ADDENDUM NO. 1

DATE: 5-28-2024

TO: ALL BIDDERS
FROM: JKF ARCHITECTURE
RE: Lenoir Community College New Aviation Center for Excellence
Project No. 2022-18

To: ALL BIDDERS
From: ATLANTEC ENGINEERS
RE: LENOIR COMMUNITY COLLEGE NEW AVIATION CENTER FOR EXCELLENCE
JKF Project No. 2022-18
Atlantec Project No. 22183

EXTERIOR MARQUEE SIGN

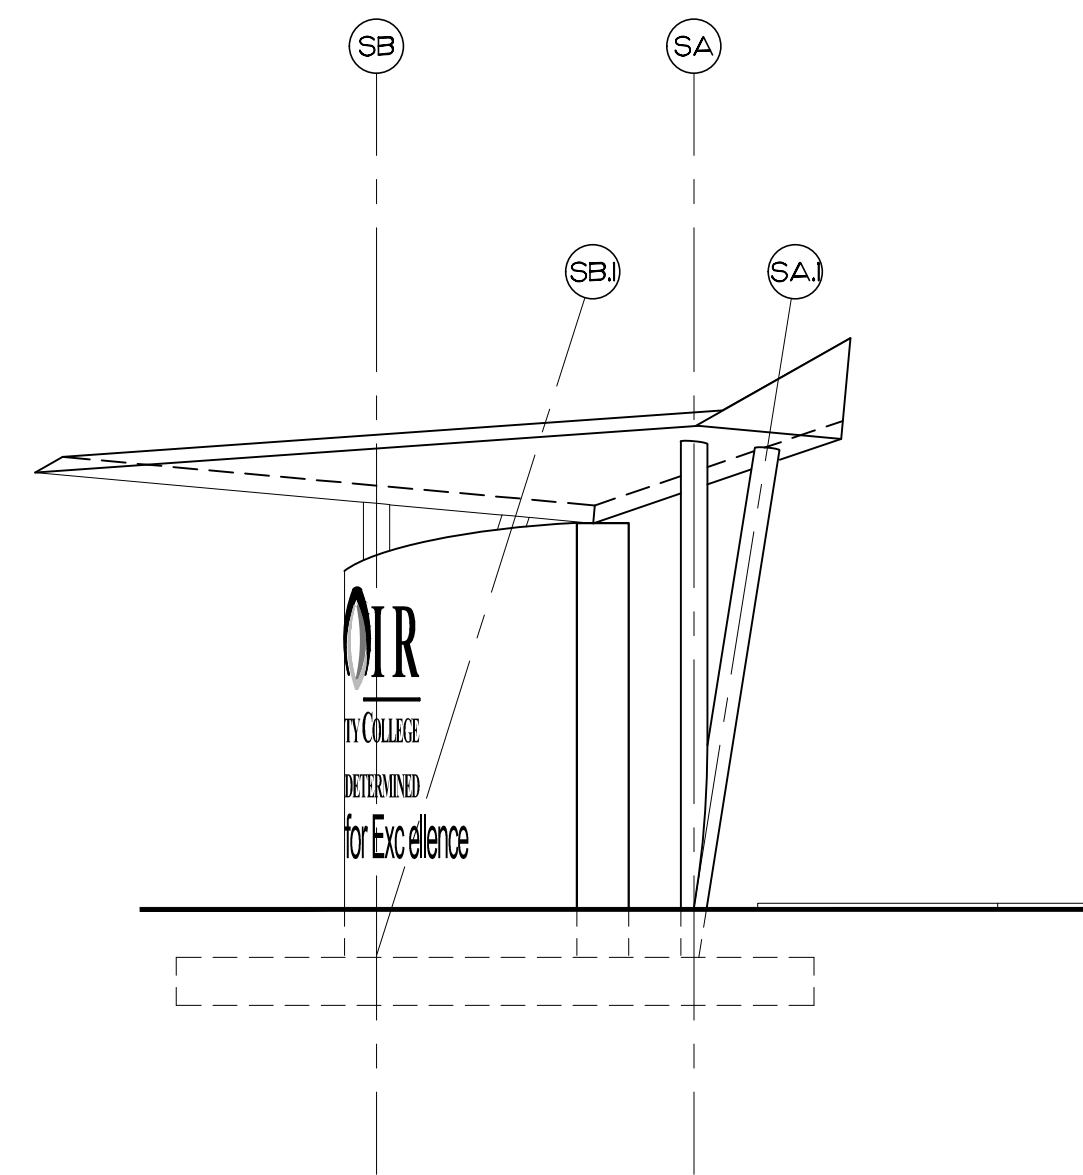
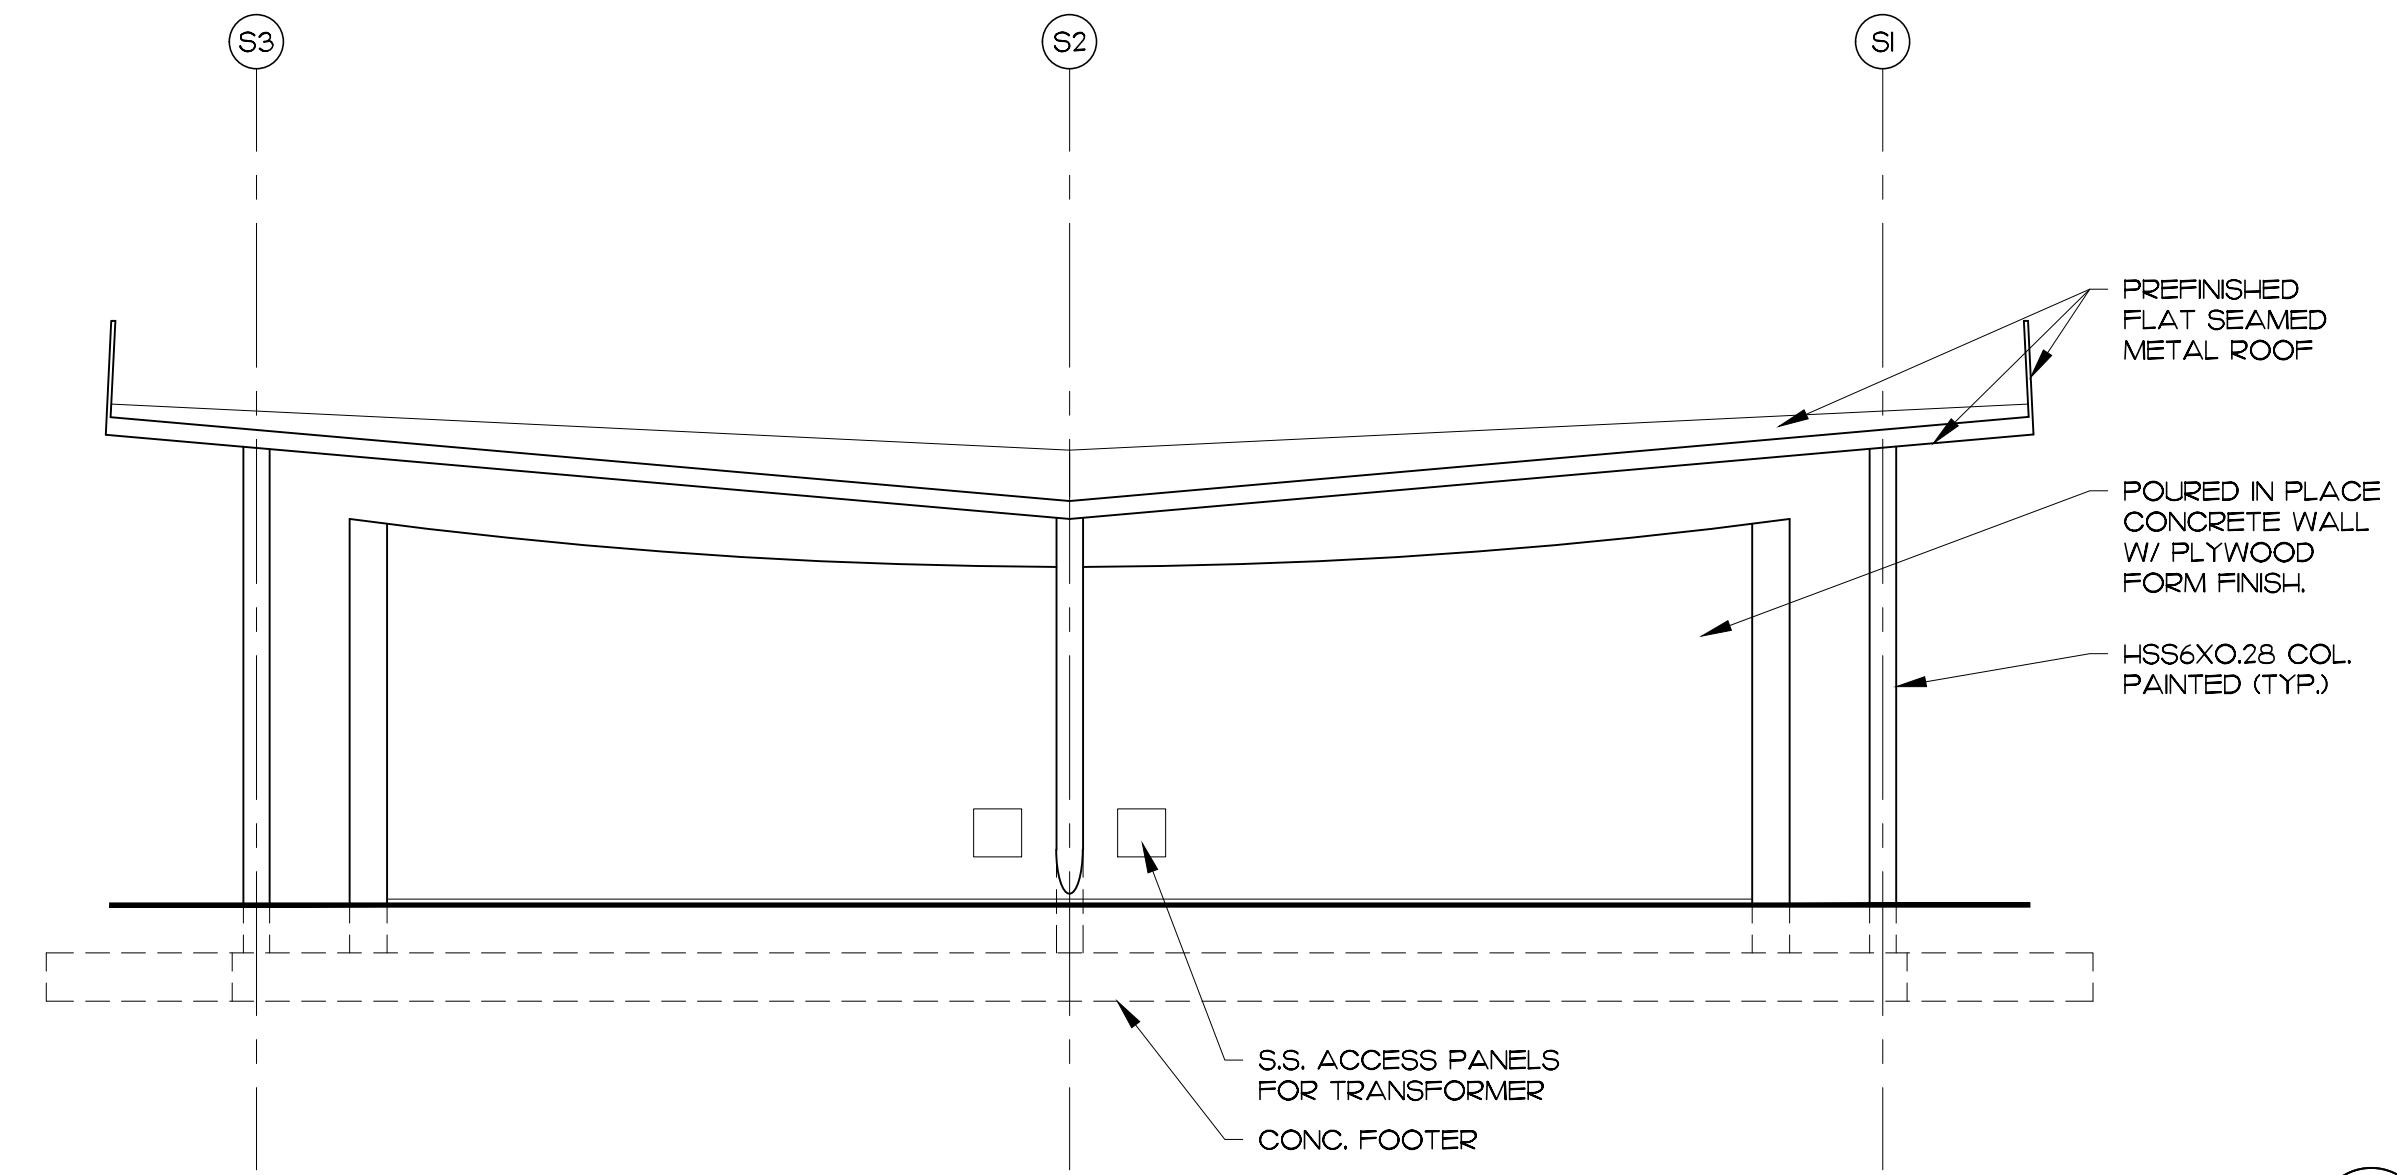
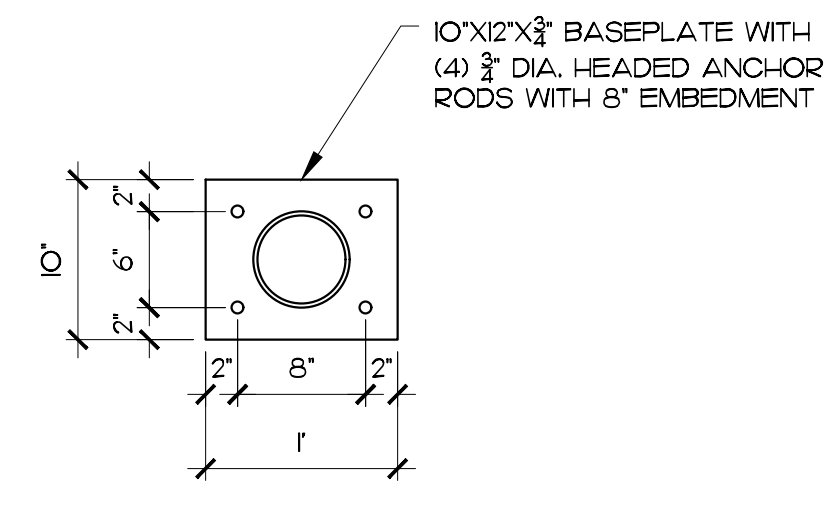
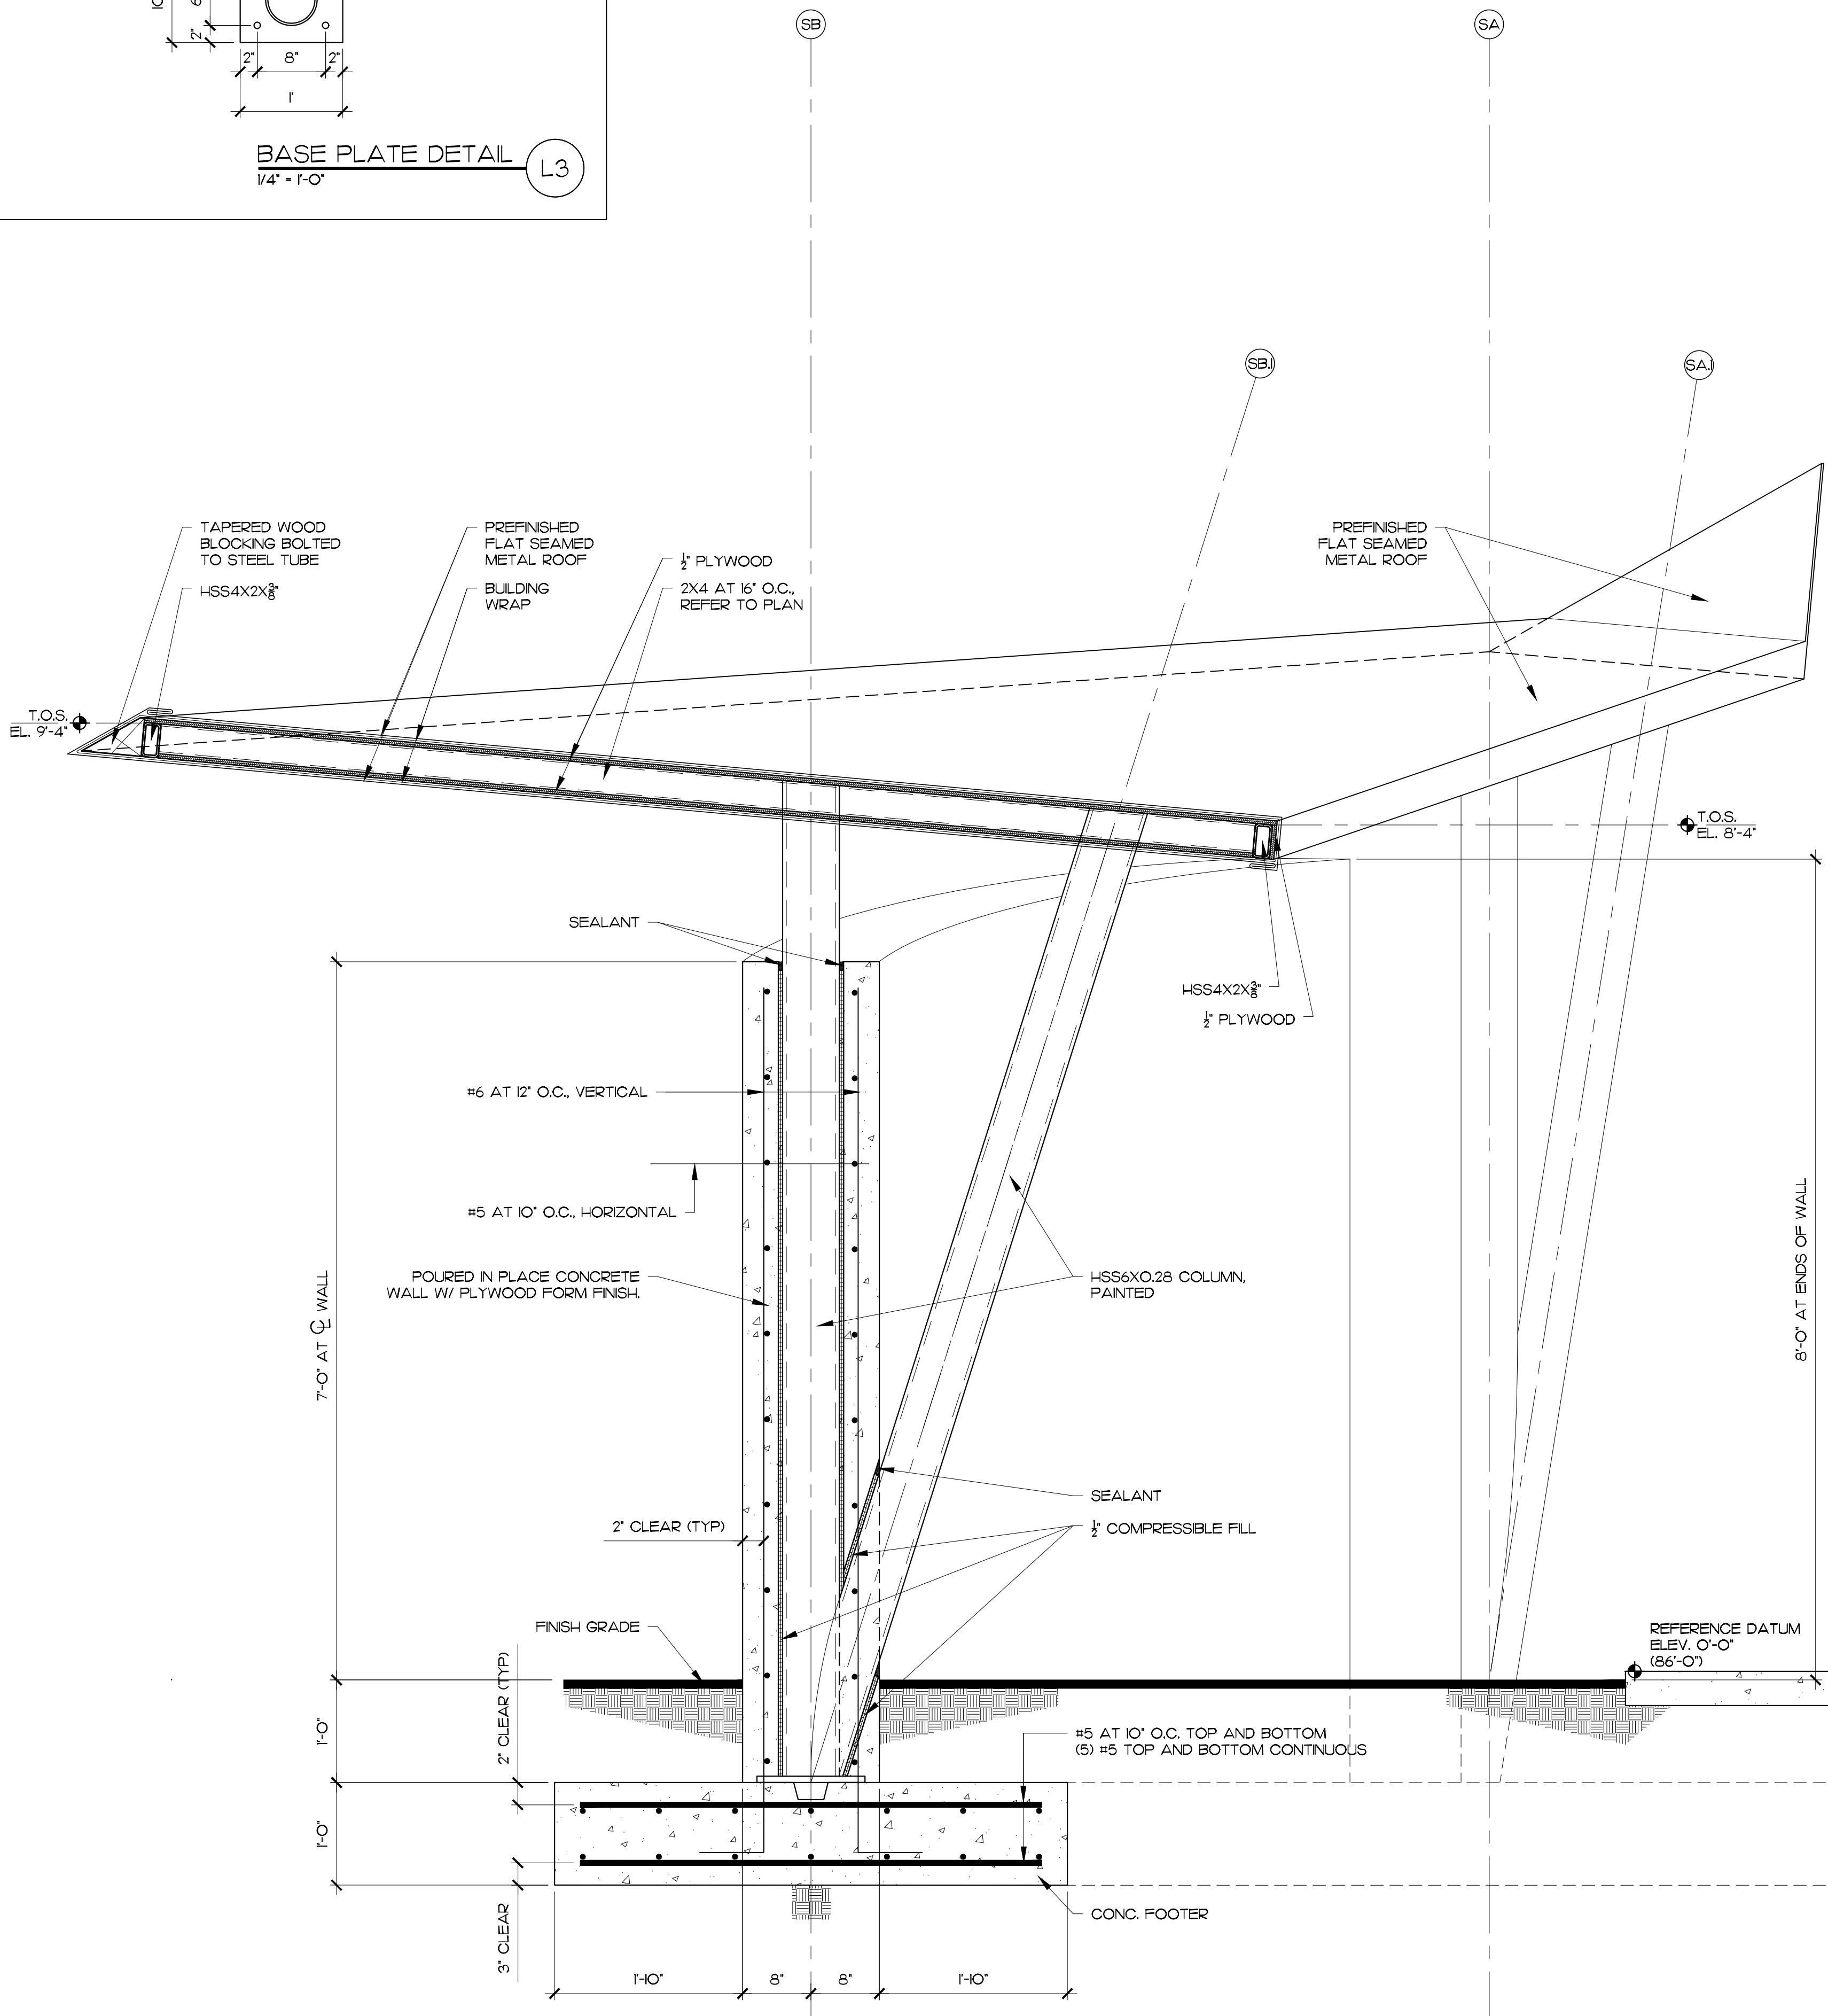
4. Add New Marquee Sign to Drawing ASP1.1, dated 2-28-2024 as follows:

5. Specification Section 101419, dated 2-28-2024; Paragraph 2.2.B is for New Marquee Sign noted on ASP1.1.
 6. Specification Section 101419, dated 2-28-2024; Add Paragraph 2.2.C as follows:
